Re: Proposed Commercial Development
Blue Hill Avenue/Temple Shalom of Milton
Milton, Massachusetts

Vanasse & Associates, Inc. (VAI) is providing detailed responses to the comments raised in the January 29, 2010 memorandum prepared by Howard/Stein-Hudson Associates, Inc. (HSH) on behalf of the Town with respect to their review of the December 17, 2009 Traffic Impact Assessment (the “December 2009 TIA”) prepared by VAI in support of the proposed neighborhood retail plaza to be located off Blue Hill Avenue (Route 138) and on the site of the Temple Shalom of Milton in Milton, Massachusetts (the “Project”). Listed below are each of the comments raised in HSH’s subject memorandum followed by our detailed response.

TRIP-DISTRIBUTION WORKSHEETS

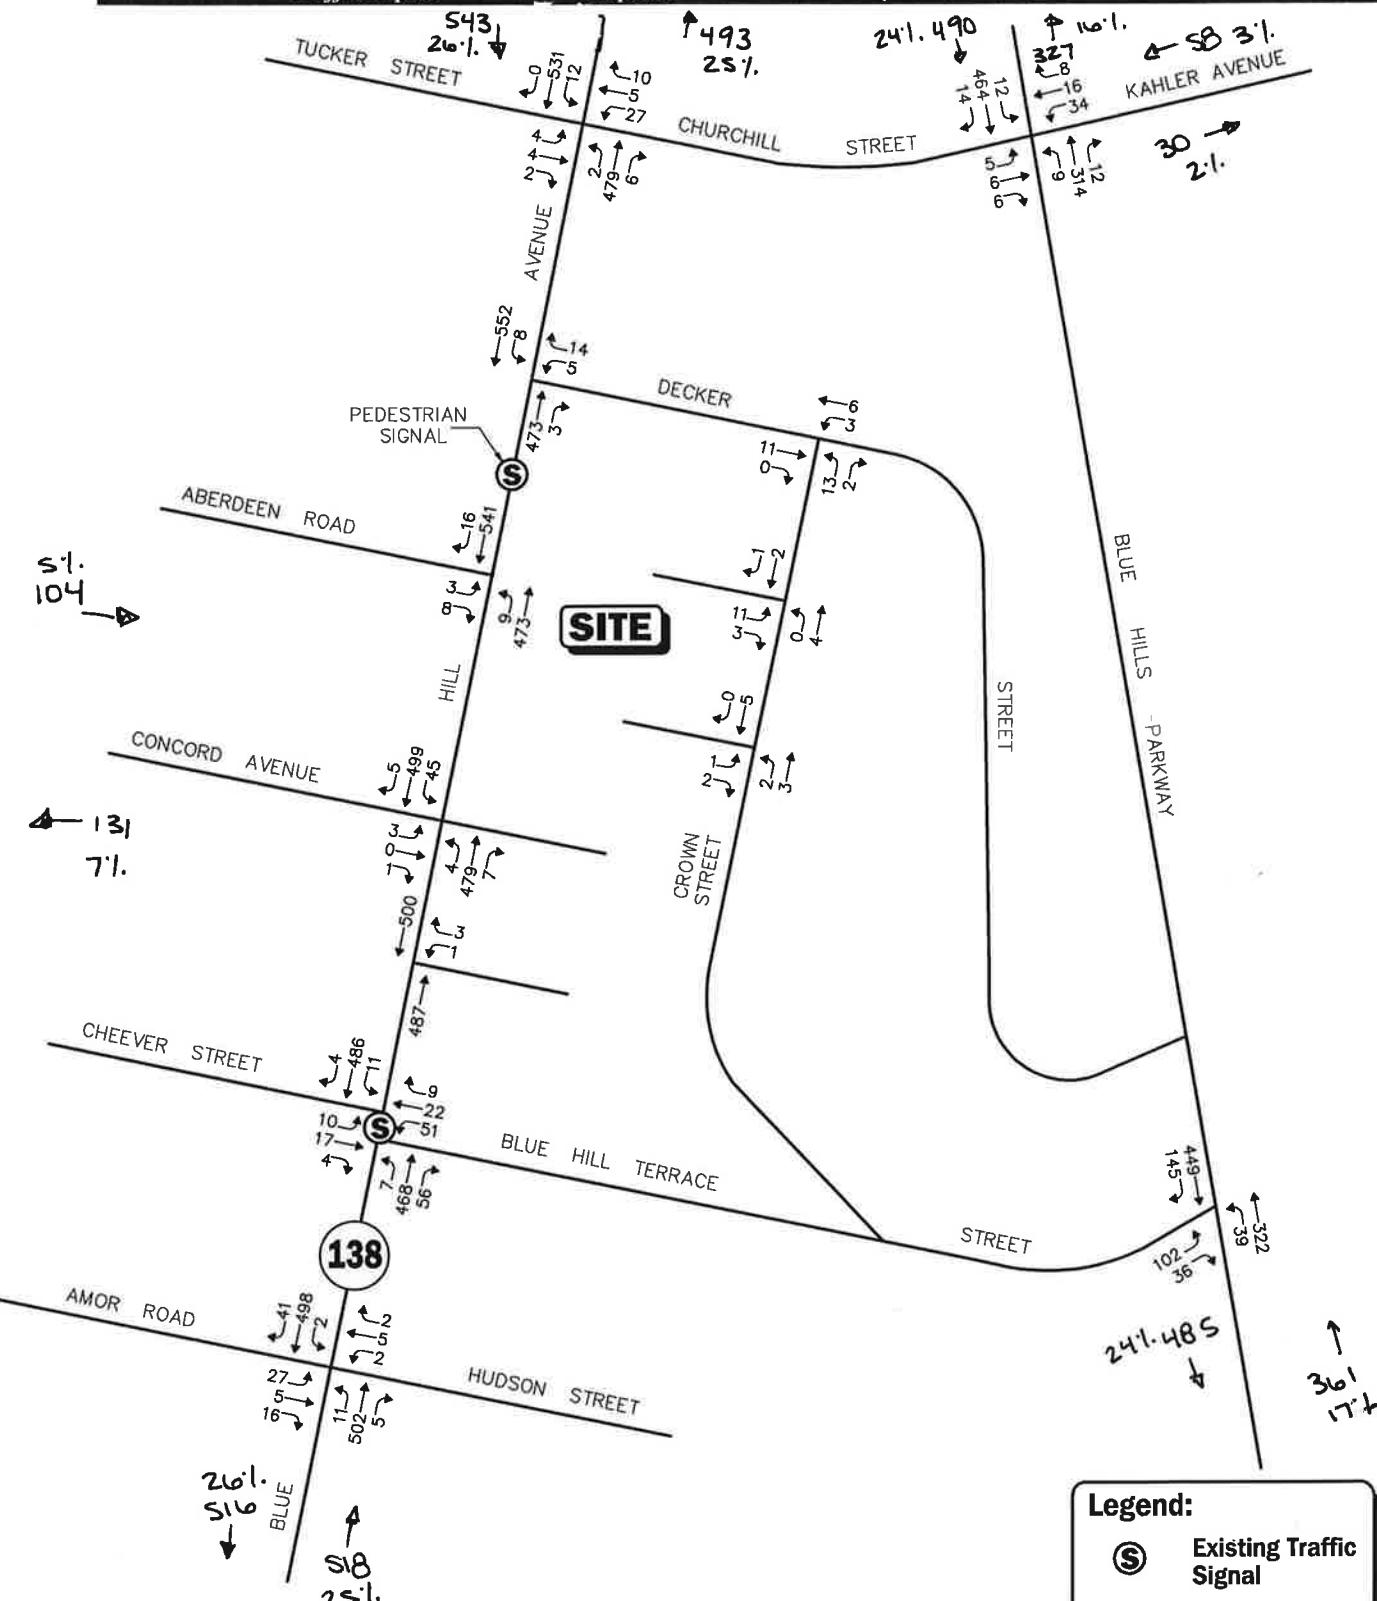
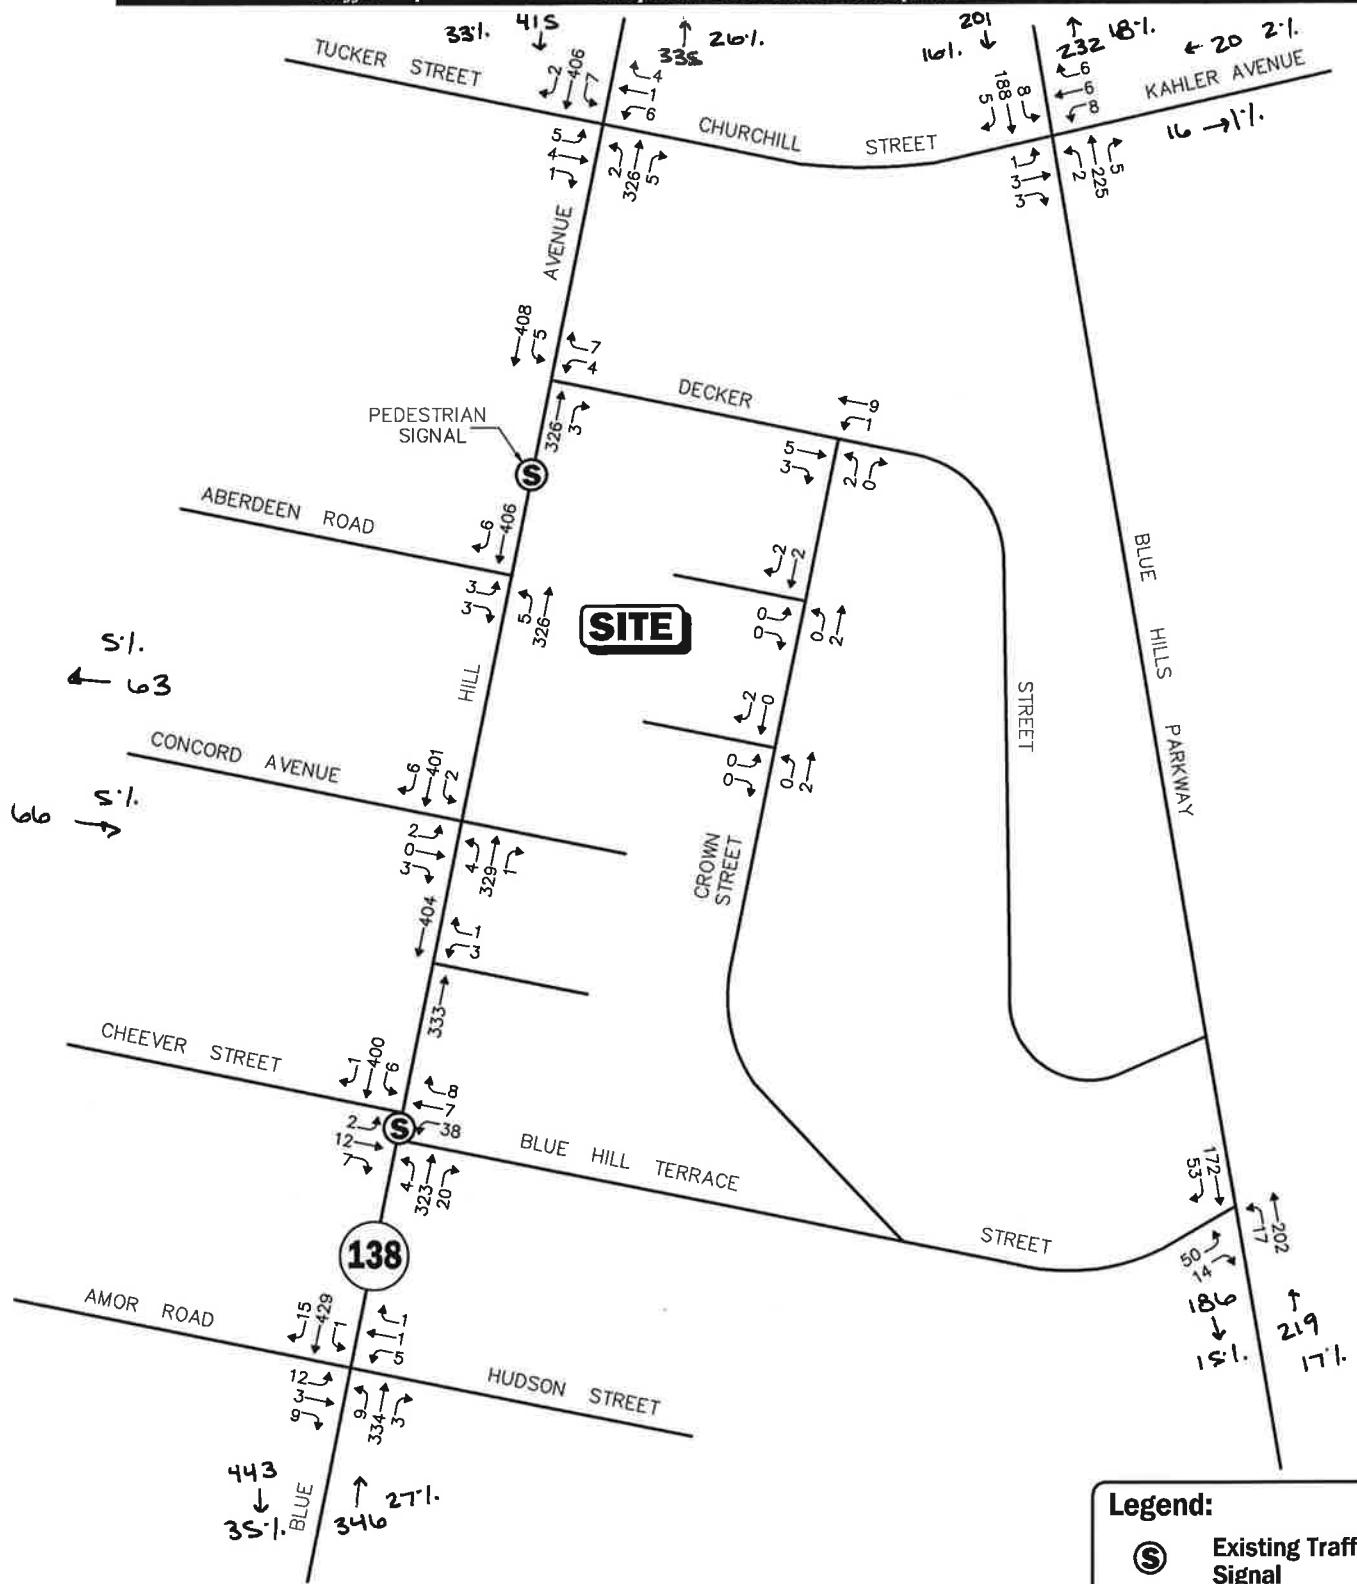
Comment: *"The proponent should provide more detail regarding how the trip distribution percentages were determined."*

Response: A figure depicting the trip distribution calculations for the Project is included in the appendix attached hereto.
